*Subject: Re: Point-by-Point Response to Reviewers' Comments on Manuscript [egusphere-2025-2012]*

*Rereview of Development and application of the Ascent-Drift-Descent Radiosonde System (ADDRS) by Cao et al*

Fig.R1 the relationship between temperature gradient throughout the entire phase of ADDR5 balloon with 30 meters string length and the rate of change in Vx (Angular Rate) attitude

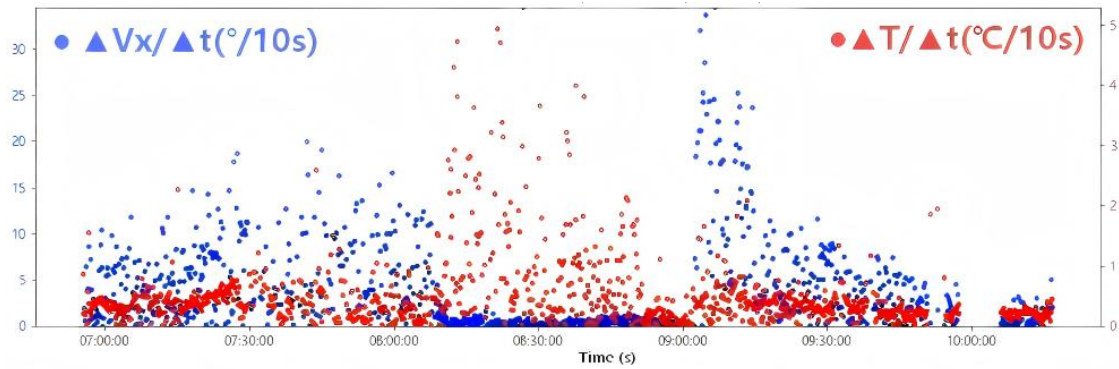
*The authors suggest that they have addressed these issues in the discussion section - I*

*struggle to see where (there are only two instances of "pendulum" and two of "turbulence" in the revised manuscript, none of these in the context of the drift phase). NB The track check document shows all changes since the original submission, it should just show the changes in the latest revision to make it more useful.*

*IF there is evidence of more pendulum motion during the drift phase then it should be presented in the main manuscript. [Note to ADDRS research team. You might want to consider adding a (small, cheap) accelerometer to your radiosonde. I have spoken to some of the authors of the paper below and they agree that accelerometer output could be used to improve the filtering of pendulum motion. Marlton GJ, Harrison RG, Nicoll KA, Williams PD. 2015 A balloon-borne accelerometer technique for measuring atmospheric turbulence. Rev. Sci. Instrum. 86, 016109. doi:10.1063/1.4905529 ]*

This conclusion is strongly supported by dedicated Balloon-borne Radiosonde Angular Motion Experiments conducted in August 2023 at the Xilinhote GRUAN site. The core objective was to directly observe the in-flight motion dynamics of the radiosonde. The methodology involved a modified GTH3 radiosonde integrated with an attitude sensor package (axial accelerometer and gyroscope, based on principles similar to Marlton et al., 2015). This setup enabled direct observation and quantification of the radiosonde's pendulum motion. A total of eight successful field launches were performed. The attitude sensors recorded raw axial acceleration and angular velocity data at 1 Hz throughout the entire flight.

(2) Evidence of less pendulum motion during the drift phase: The data confirmed the attenuated pendulum motion during the stable drift phase. Specifically, when the system transitions from ascent to stable drift (Fig.R1 about 08:15:00), the angular rate decreases significantly and the pendulum amplitude decays rapidly. Data analysis revealed that during ascent and descent, the rate of attitude change (e.g., angular velocity) is high while the rate of temperature change is low. Conversely, during the drift phase, the rate of temperature change is relatively high while the rate of attitude change is minimal. This physical understanding validates the basis for applying a smaller filter window during the calm drift phase in our data processing.
